UNITED STATES PATENT AND TRADEMARK OFFICE

APPLICATION NO.	FILING DATE	FIRST NAMED INVENTOR	ATTORNEY DOCKET NO.	CONFIRMATION NO.
09/818,470	03/28/2001	Mark E. Poole	sfi-1	9560

Office Action Summary

DETAILED ACTION

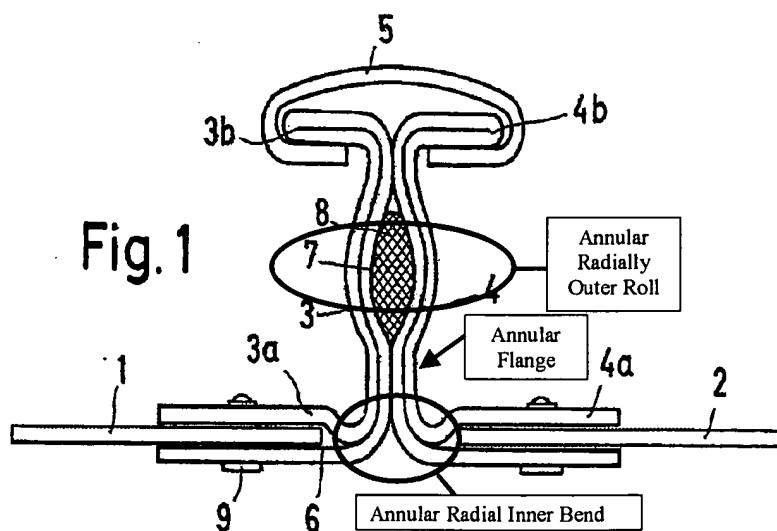
In regards to claim 1, in Figure 1 below, DT 1212356 discloses an apparatus for connecting and sealing duct sections, the apparatus comprising:

(A) first and second connectors (3, 4), each connector comprising:

(a) a tubular member (3a, 4a);

(b) an annular flange, extending radially outwardly from an outer end of the tubular member; and

(c) a rolled edge, comprising:

(i) an annular radially inner bend, attached to the outer perimeter of the annular flange;

(ii) an annular radially outer roll, adjacent to the radially inner bend;

(iii) an annular rounded perimeter (3b, 4b), adjacent to the annular radially outer roll and at the outer perimeter of the annular flange, the annular rounded perimeter is rounded inwardly, toward the outer end of the tubular member; and

(iv) whereby a tube cavity is defined within the annular radially outer roll and annular rounded perimeter (minute clearance between the two elements);

(B) whereby an excess duct sealer trough (7) is defined between rolled edges of the first and second connectors; and

(C) a plurality of fasteners (5) connecting the annular flange of the first connector to the annular flange of the second connector.

In regards to claim 2, DT 1212356 discloses a gasket (8), carried between outer annular surfaces of the annular flanges of the first and second connectors, the gasket having a first side surface directed toward the outer annular surface of the first connector and a second side surface directed toward the outer annular surface of the second connector.

In regards to claim 4, DT 1212356 discloses a duct sealer (8), carried firstly between the annular flange of the first connector and the annular flange of the second connector.
